FIELD INSPECTION

Project Name:	Mountain Valley Pipeline	Inspector:	Matthew Grant
Inspection Date:	Wednesday, March 6, 2019	Project Contact:	Brian Clauto
Spread: Giles County MP216-MP215 St#11451-11361	Spread G	Weather (Wet/Dry/Rain):	Dry

FIELD INSPECTION PHOTO LOG

Fig. 1 St#11427+00 soil pipe protected by P1 fence

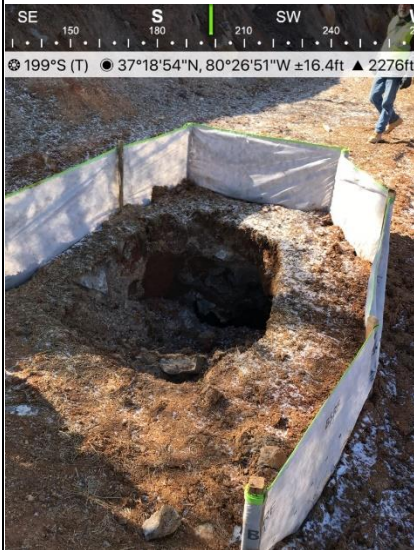
- Streams / wetlands inspected included: S-0013, S-0014, W-CD12, NN11
- St#1421+50 sump end treatment is undermined
- St#11361+75 sump end treatment is undermined
- St#11361+00 sump end treatment is undermined
- St#11428+00 small hole, 11427+50 small hole, 11427+00 soil pipe feature and 11424+00 small hole inspected with Draper Aden and DEQ personnel Will Orndorff. Karsts features were protected.
